Steering Stub Shaft Hardware Replacement

Mack

Model Years	Models
2024-2025	GR, PI

Mack trucks has determined that certain GR, PI model trucks could have the incorrect steering shaft support bearing mounting hardware installed. On affected vehicles follow the instructions below to remove the steering shaft support bearing mounting hardware and replace with new screws and nuts.

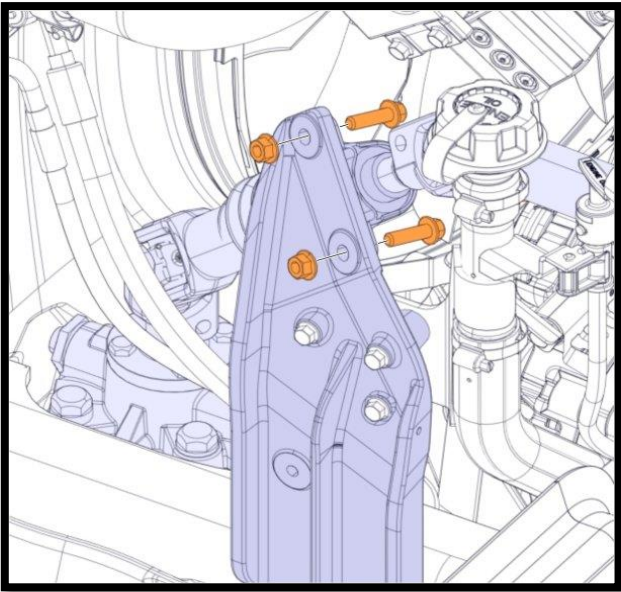
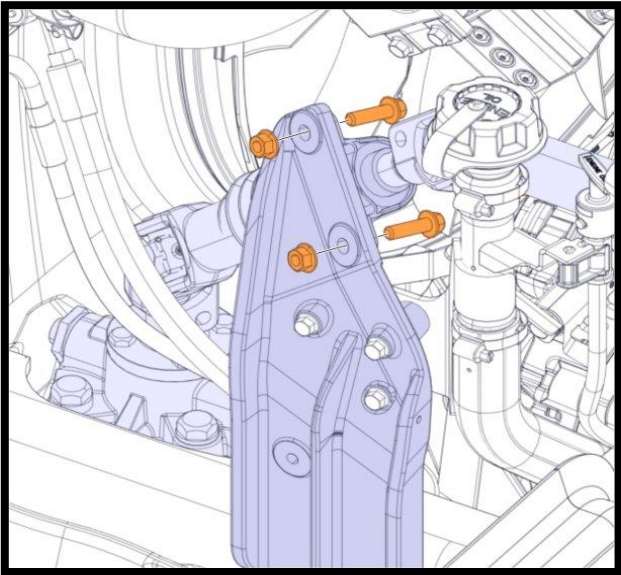
8. Locate the two screws securing the steering shaft support bearing to the bracket.
9. Remove the two flange nuts and screws.

- 10. Discard the nuts and screws.
- 11. Install the new screw **984754** GR or **995494** PI and **990951** nuts.

Tightening torque	
Steering shaft, screws	85 ±5 Nm (63 ±4 lb _r ·ft)
